# AQUALLIANCE

April 22, 2022

Re: Colusa Subbasin Groundwater Sustainability Plan

These comments on the December 2021 Colusa Subbasin Final GSP (Colusa GSP) are being provided to support our recommendation that the California Department of Water Resources and the State Water Resources Control Board find that the GSP is incomplete because of multiple deficiencies and the overall failure of the document to comply with the statutory and regulatory requirements of the SGMA and the Water Code. These comments are supplemental to AquAlliance's previous comments provided on the September 2021 Draft Colusa Subbasin GSP, which are attached in Final Colusa GSP in Appendix 2B-2 (pdf pp. 606 to 662). The proposed sustainable management criteria presented in the Colusa GSP fail to demonstrate as required by SGMA that the goal of groundwater sustainability is achievable and will occur within 20 years of GSP adoption to prevent: (1) chronic lowering of groundwater levels, (2) reduction of groundwater storage, (3) degraded water quality, (4) inelastic land subsidence, and (5) depletions of interconnected surface waters. The Final Colusa GSP fails to protect the beneficial uses for all users of gr

# AquAlliance Exhibit 4

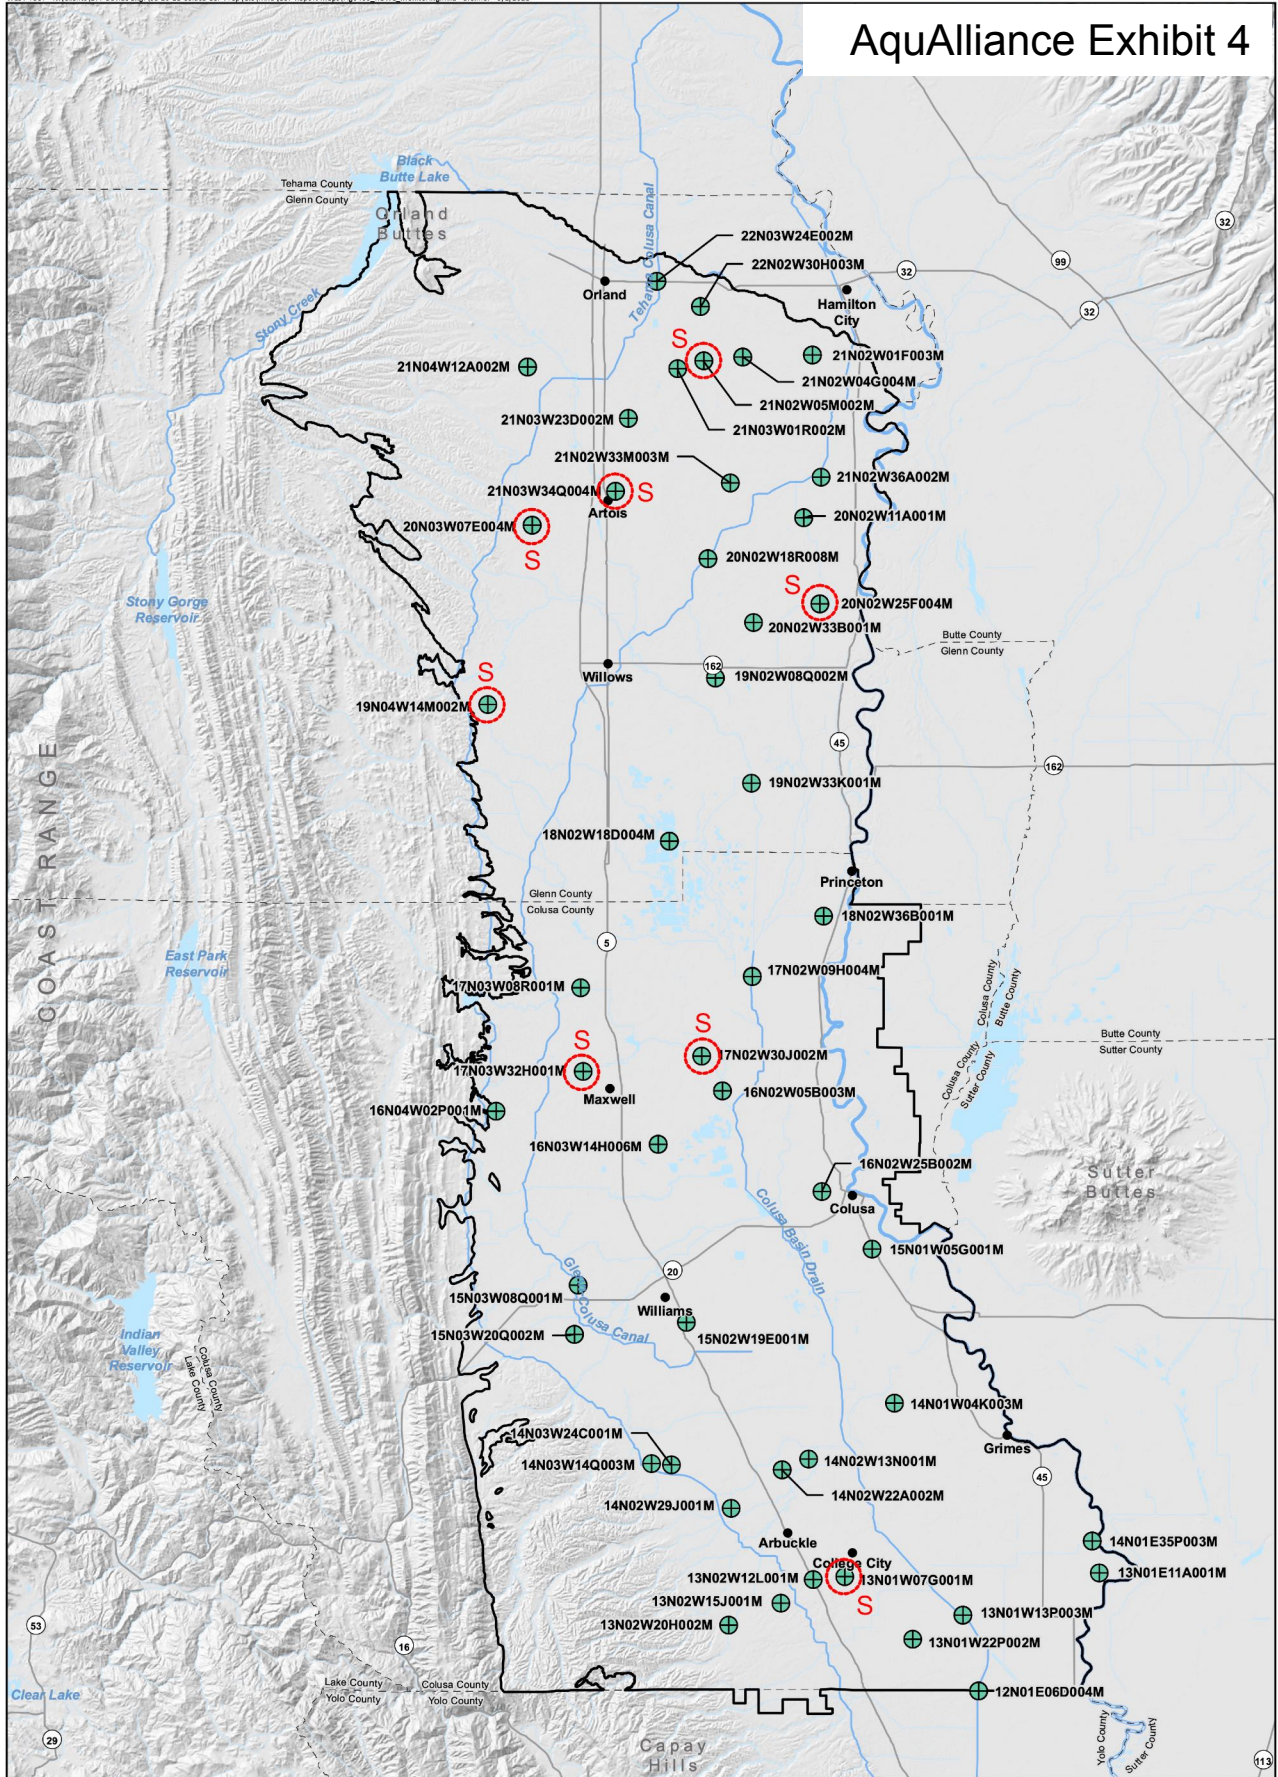
This well is one of two RMN wells closest to the City of Orland. Glenn County, as the Colusa GSP Preface notes, has had 282 reports of problems associated with groundwater wells, with about 65 percent of those being reports of dry wells. AquAlliance Exhibit 3 is a screen capture of the SGMA Data Viewer showing that most of the reported dry wells in the Colusa Subbasin are near Orland. The October 20, 2021 comment letter by the City of Orland Council on the Draft Colusa GSP noted that 150 domestic wells had gone dry in the summer of 2021 (pdf pages 683 and 684).

Modified Figure 4-6

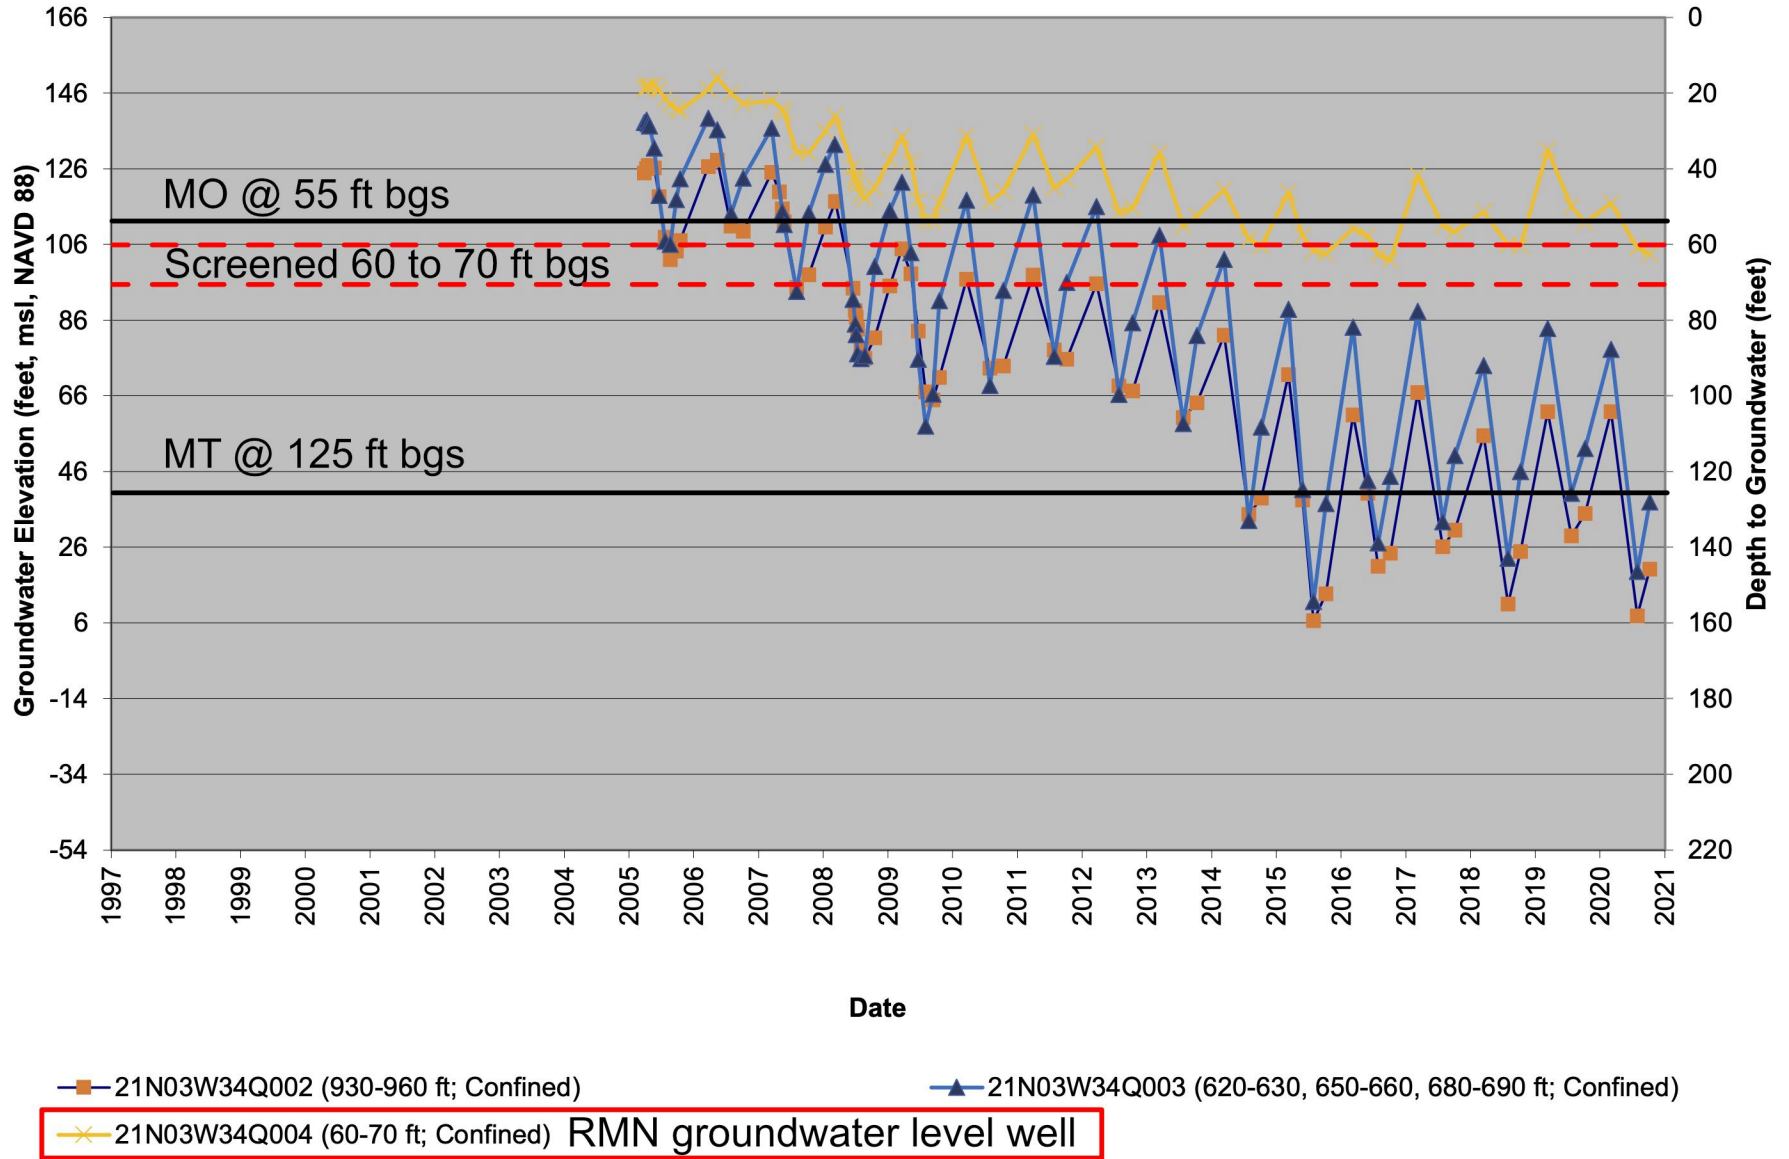
An additional issue with the requirement for MT exceedance for 24 consecutive months is that it may prevent the determination of an unreasonable result from lowering of groundwater levels. The Colusa GSP monitoring plan utilizes 8 of the 48 RMN groundwater level monitoring wells, or 17 percent, shown in Table 5-2, that have MT depths that are at or below the screened interval of the well. This means that the chronic lowering of groundwater level sustainability criteria at these wells can't be continuously measured, and the water levels in these wells will need to be either reported as not available or reported as being above the MT! The MT criteria in all but one of these 8 wells are set at the 20<sup>th</sup> percentile domestic well depth. These 8 wells are identified by a footnote 3 in Column F of AquAlliance Exhibit 1. AquAlliance Exhibit 4 is a modification of Figure 4-6 in the Final Colusa GSP that identifies the locations of these 8 wells.

These 8 wells monitor the shallow aquifer zone, shallower than 200 feet, and are distributed across the subbasin. It is likely that at least one or more ~~all-four~~ of the required groups of 25% RMN monitoring wells will have at least one of these 8 wells. **This suggests that in the Colusa Subbasin an undesirable result from the chronic lowering of groundwater level can never occur, regardless of how low groundwater levels decline.** As an example, AquAlliance Exhibit 5 is a modification of Figure 3A-47 (pdf page 3319) that shows the hydrographs for the 21N03W34Q002-004M cluster of wells near the City of Artois. Well 21N03W34Q004M (CASGEM 25790) is one of the Colusa RMN wells, sixth up from the bottom in AquAlliance Exhibit 1. Horizontal lines are added to this figure at the approximate depths of 55 feet bgs for the management objective (MO) and 125 feet bgs for the MT, along with dashed lines for the well's screen interval at 60 to 70 feet bgs, AquAlliance Exhibit 1 (Columns E, F and C). The groundwater levels can be measured to confirm the MO sustainability, but whenever the level declines below 70 feet, no measurements of shallow groundwater are available in this well. Therefore, groundwater levels between 71 and the MT at 125 feet bgs will always be unmeasured, which means that the monitoring group with this well can never have the groundwater level in all 25% wells lower than their respective MTs.

**Modified Figure 4-6**  
**Representative Groundwater Level Monitoring Network**  
 Colusa Groundwater Authority and Glenn Groundwater Authority  
**Final** Colusa Subbasin Groundwater Sustainability Plan

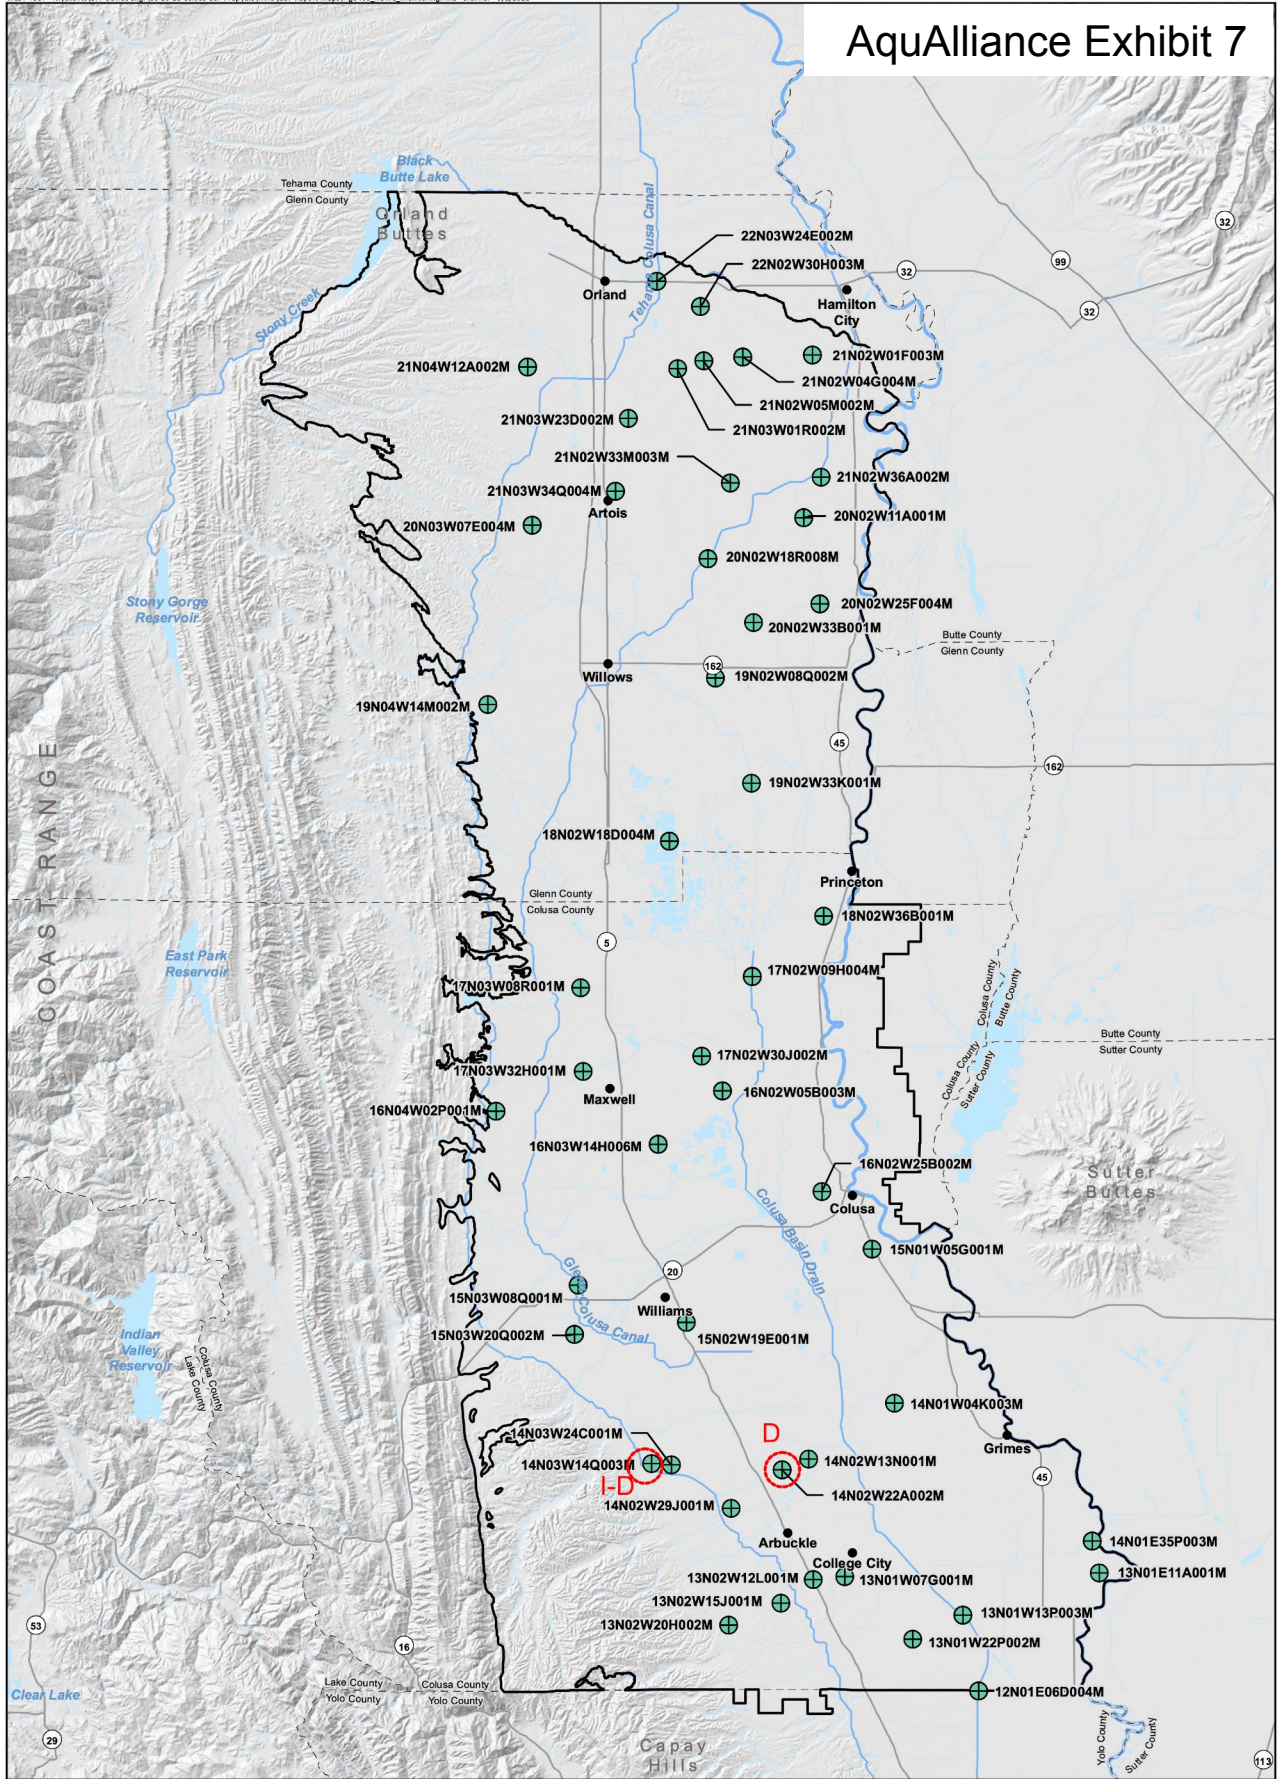
e) The Colusa GSP, without a clear explanation, has reduced the number of wells in RMN groundwater level wells screened in the deep aquifer zone, defined by DWR<sup>5</sup> as greater than 600 feet below the ground surface, from 17 (possibly 18) of the 48 RMN wells in the Draft GSP down to 2 (possibly 3) in the Final GSP. The deep aquifer zone is used for agricultural production and a portion of the recharge to the deep zone comes from the overlying aquifer zones.<sup>6</sup> Therefore, sustainability criteria and extensive monitoring of deep aquifer zone groundwater levels, changes in groundwater storage, and groundwater water quality need to be included in the GSP. The Final GSP didn't change the total number of RMN groundwater monitoring wells, 48, but it did remove 20 of the Draft GSP wells and replaced them with 20 new wells. The well substitutions appear to mostly remove wells monitoring the deeper aquifer zone with wells screened in shallower zones. Both the original draft wells and the new final wells appear to be at or near the same location, just monitoring different zones. AquAlliance Exhibits 1 and 2 list the RMN groundwater level wells for the Final Colusa GSP and the Draft Colusa GSP, respectively. The wells in bold font in both exhibits are those that have been changed from the draft to the final Colusa GSP. AquAlliance Exhibits 6 and 7 are modified Figures 4-6 from the draft and final Colusa GSP, respectively, that show the deep aquifer zone RMN groundwater level monitoring wells. For the Final Colusa GSP, the deep aquifer zone RMN groundwater level wells are now only in the southern portion of the subbasin. The Final Colusa GSP has no RMN groundwater level wells monitoring the deep aquifer zone in the northern two-thirds of the subbasin.

declines in groundwater levels for at least 10 years.<sup>7</sup> Sustainable management of the Colusa Subbasin requires that this critically important aquifer zone be monitored. SGMA doesn't have a cap or limit on the number of monitoring stations, so the 20 monitoring wells that were removed must be returned to expand the RMN to 68 wells to monitor groundwater levels and water quality.

**Modified Figure 3-49. Cumulative Change in Groundwater Storage for Current and Future Conditions Baseline Scenarios**

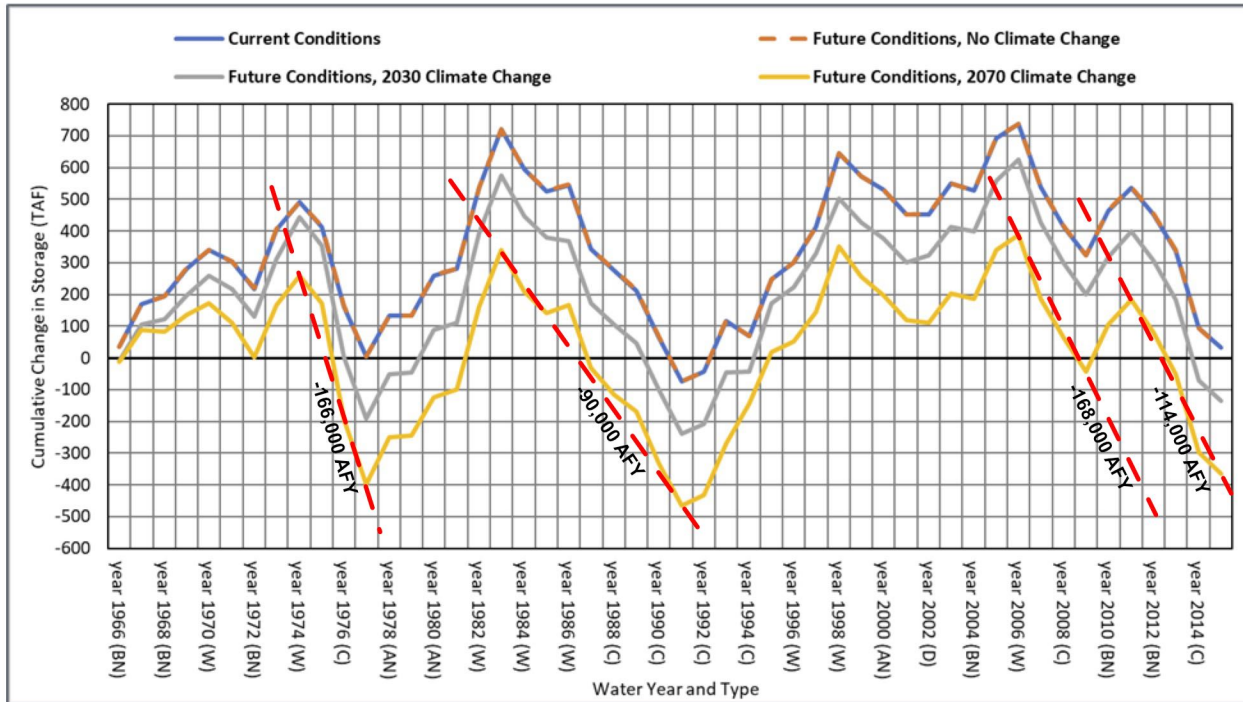
As an example of a drought-based methodology, AquAlliance Exhibit 10 shows the annual loss in groundwater storage that during the most recent simulated periods of drought lasting more than 3 years having an average annual loss of 134,500 afy. Using this average rate of annual drought storage loss for 3 years, the decline in groundwater level would be of approximately 8 feet ( $(3 \text{ yrs} \times 134,500 \text{ afy}) / 52,000 \text{ af/f} = 7.8 \text{ feet}$ ). Note, see Comment No. 9 for calculation of the 52,000 af/f storage volume per foot of groundwater level decline. This suggests that the depth of the MTs could be set at 10 feet or less below the MO depth to accommodate future periods of extended drought without causing undesirable impacts to all beneficial uses and users, in particular wells of domestic and small agricultural groundwater users. It should be remembered that declaration of an undesirable result would occur only after groundwater levels decline below the MT depth. This would allow a drought of 5 years under the Colusa GSP 24-month requirement before an undesirable result would be declared with possibly an additional 5 feet of groundwater decline and 104,000 af of storage loss. Perhaps because of the 24-month MT exceedance requirements, the MT depths should be set to allow only 1 year of drought storage loss with the assumption that an additional 2 years of drought can occur before an undesirable result is declared. This would make the sustainability management of the Colusa Subbasin groundwater levels consistent with the Historical baseline.
